**RESOLUTION NO. R26-67**

A RESOLUTION OF THE MAYOR AND COUNCIL OF THE CITY OF COLUMBUS, NEBRASKA, APPROVING CHANGE ORDER NO. 1 TO THE CONSTRUCTION CONTRACT WITH RUTJENS CONSTRUCTION, INC. IN THE AMOUNT OF \$17,854.85 FOR CHANGE PROPOSAL REQUESTS 1 THROUGH 5 FOR COLUMBUS NORTH WELL NO. 20 PROJECT.

## CHANGE ORDER NO. ONE

Owner: City of Columbus, Nebraska  
Engineer: HDR  
Contractor: Rutjens Construction, Inc.  
Project: Columbus Well No. 20

6651 33RD AVE. COLUMBUS, NE

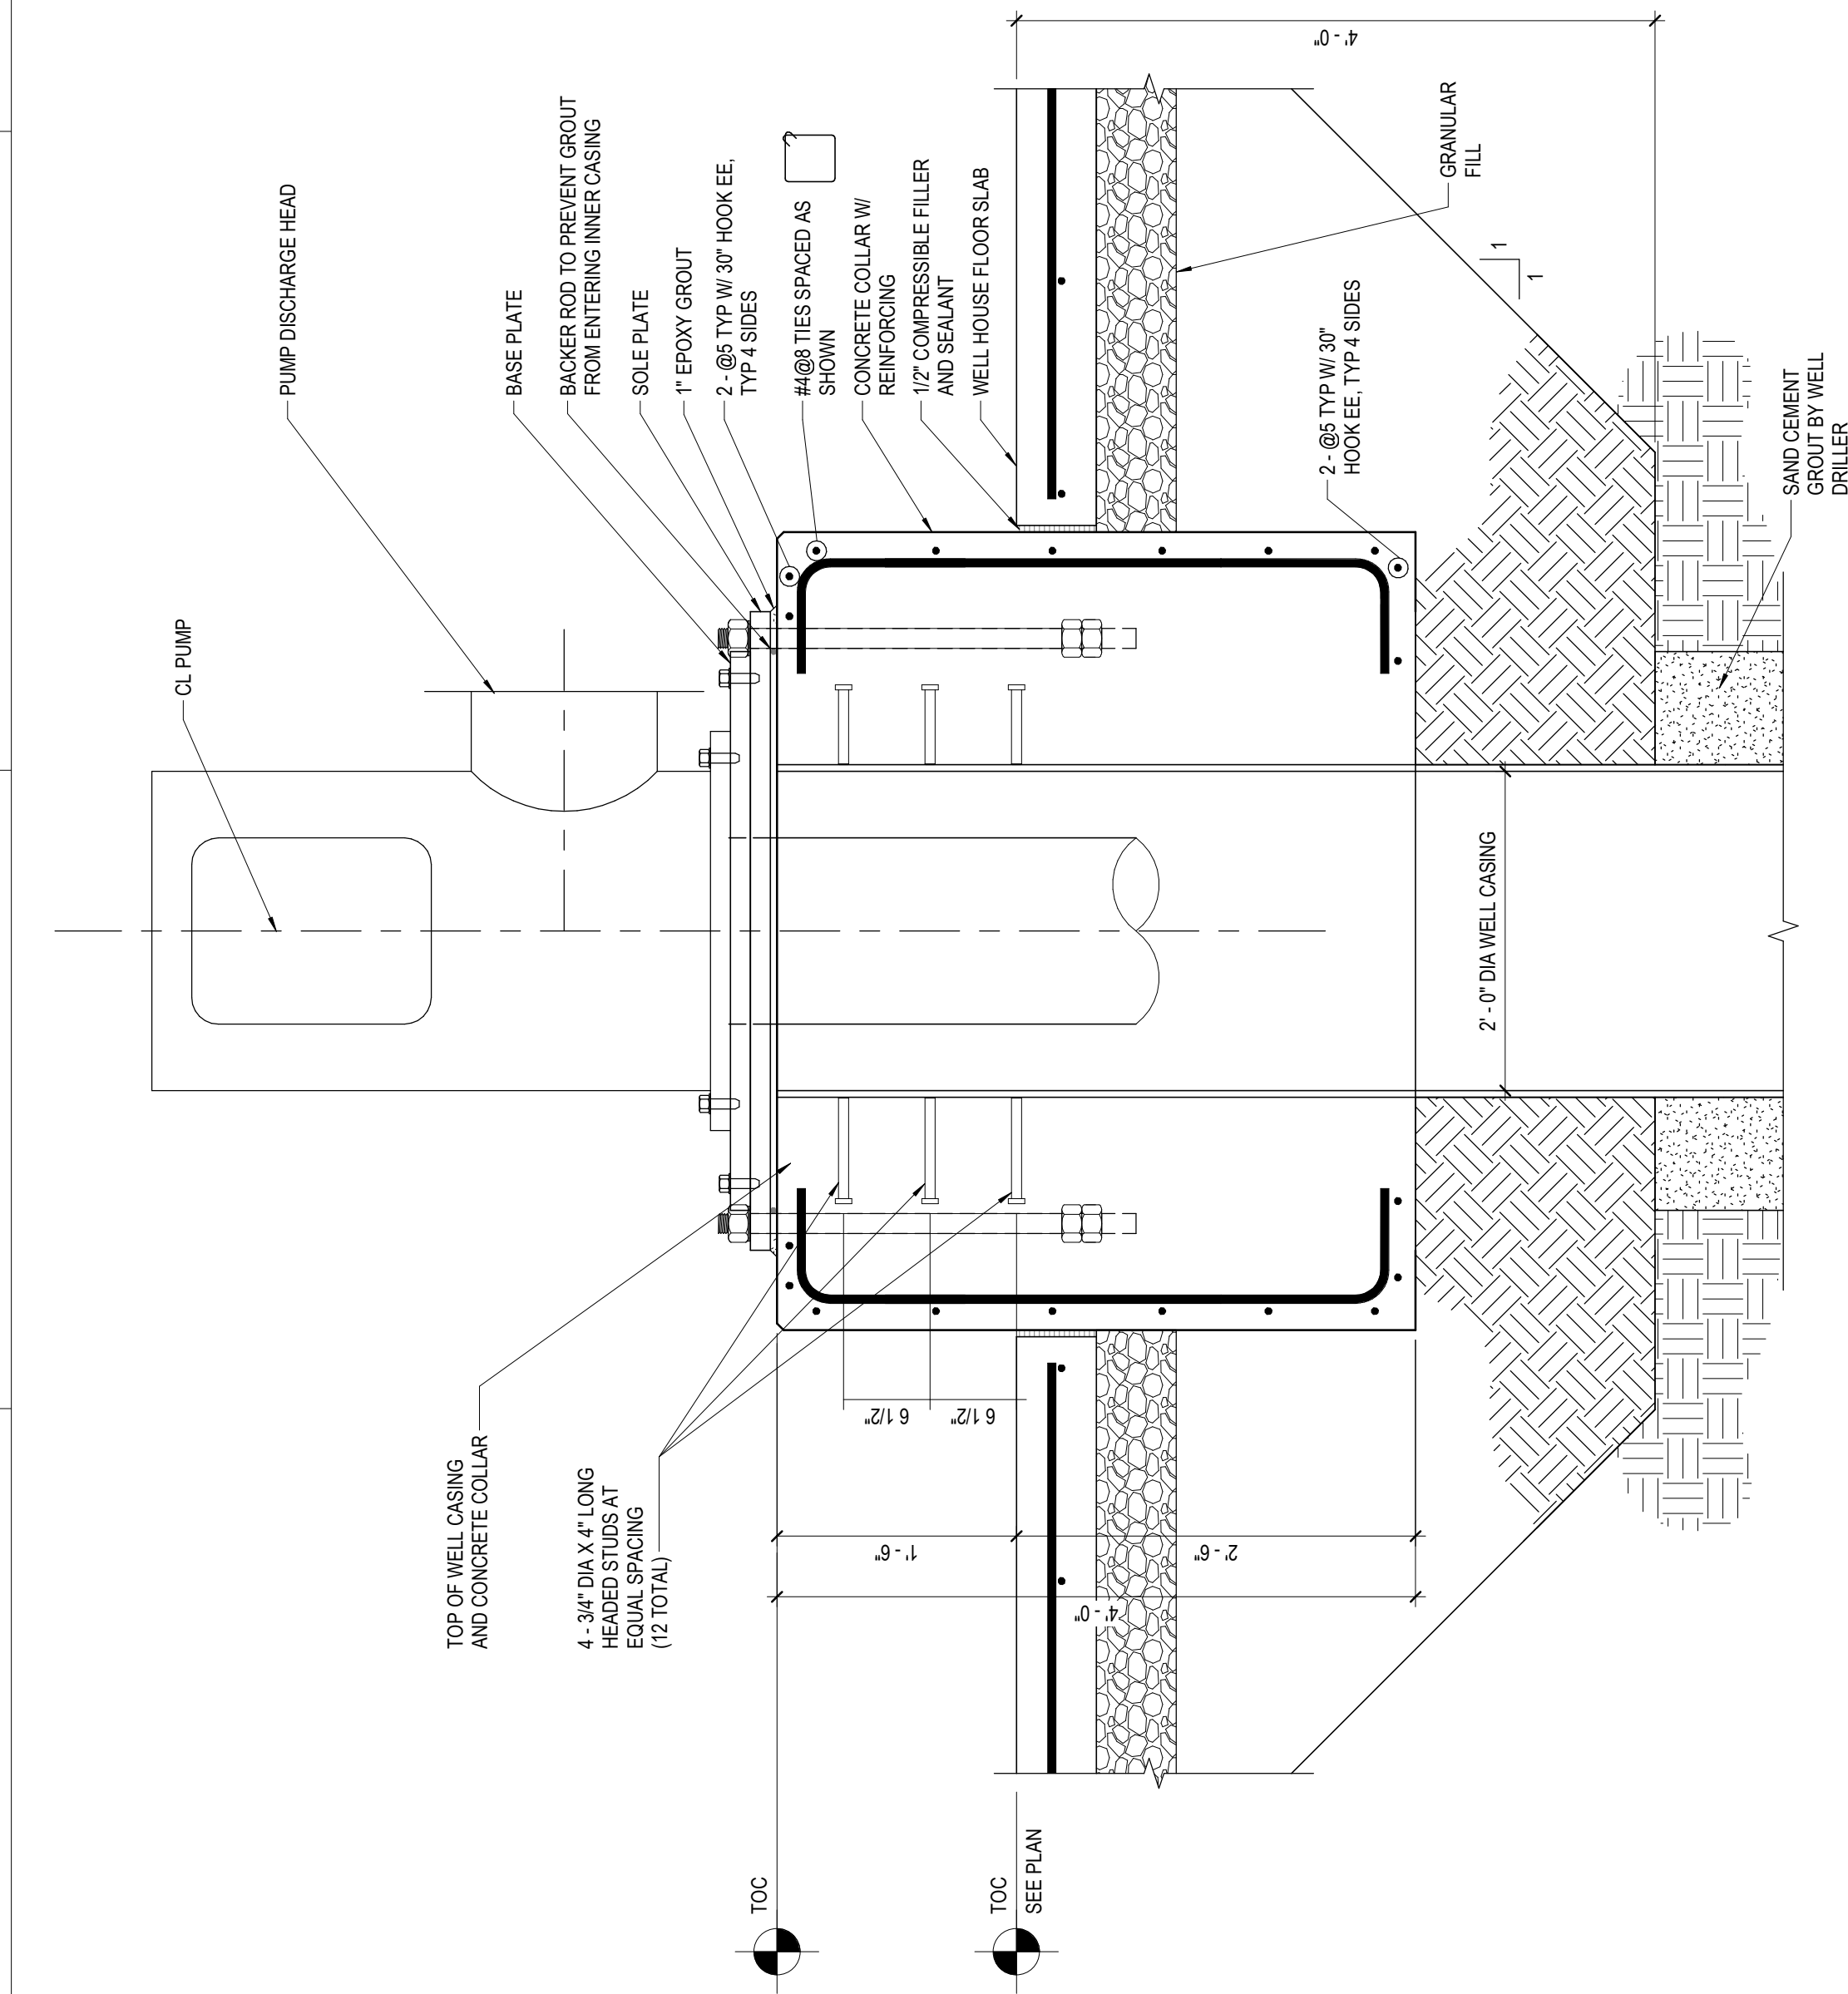
1. Revise the wall section for Well No. 20 as shown on the attached plan sheets dated 3.18.2026 for CPR No. 5.
